Product Change Notification: PCN-22-156348

AMP DUOPLUG Mark II

Description of Changes

Parts produced not in Qingdao plant

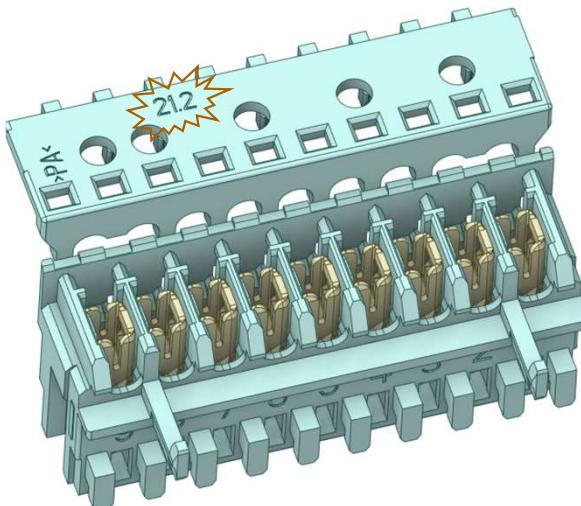
Cavity ID starts with number
(the actual ID can be changed due to different
mold and cavity)

Parts produced in Qingdao plant

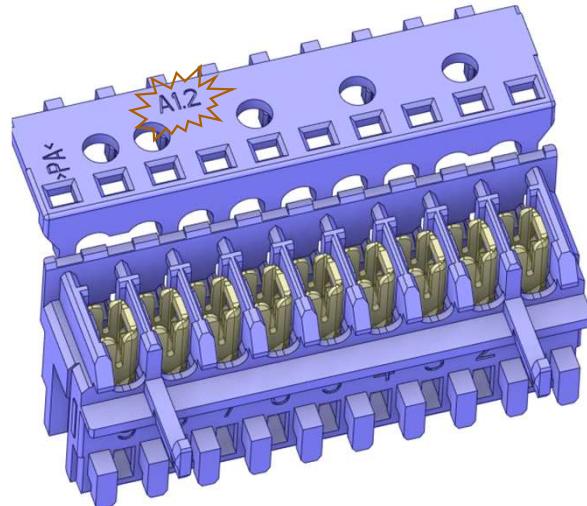
Cavity ID starts with letter
(the actual ID can be changed due to different
mold and cavity)
